RE: Objection Submission DA2024/1806
26A Lakeview Parade, Warriewood NSW 2102

This submission is prepared for the consideration of the Planning and Development section of Northern Beaches Council, regarding Development application DA2024/1806 for a proposal for Demolition works and construction of a garage and secondary dwelling. This objection is prepared on behalf of the owners of 6B Elimatta Road, Mona Vale.

Figure 2: 3B Elimatta Road, Mona Vale. Potential View outlook corridors impacted by proposal indicated.

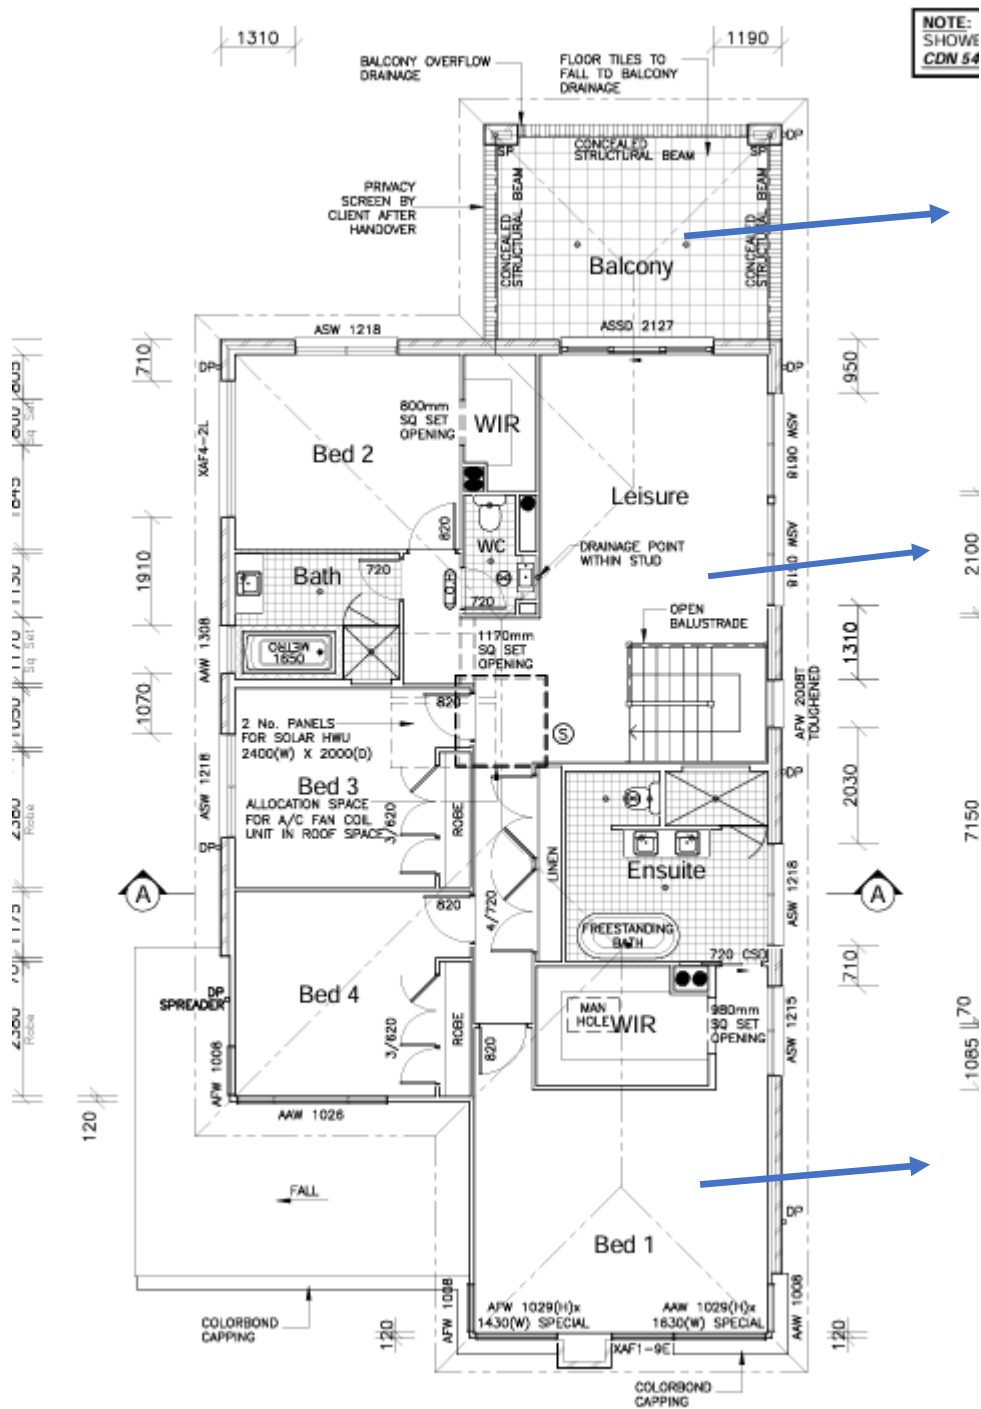
The submitters site currently has a two-storey dwelling with attached garage. The dwelling has outlook to the north, east and south of the site. The layout of the first floor is provided in figure 2 below with potentially impacted view outlooks.

As is clear discernible, high amenity views are afforded from the first floor living room and master bedroom and should the first-floor addition be overlaid the existing garage, the view will be obliterated. This will result in further impacts to the occupant's enjoyment of the rooms but also ground level private open space at the rear of the dwelling due to the proximity and bulk and scale of the building. These are detailed further in the following headings. Relevantly though, clearly there is impact and this has not been adequately discussed and or analysed against relevant court principle and sections C1.3 View Sharing of Council's DCP. As a minimum, Council should be requesting the applicant to engage in a proper analysis of the impact including view loss diagrams and analysis of the impact against the Court Principles and DCP to enable Council to properly be informed and assess potential impact of the development. Additionally, view can be obtained from main living rooms and not just bedrooms.
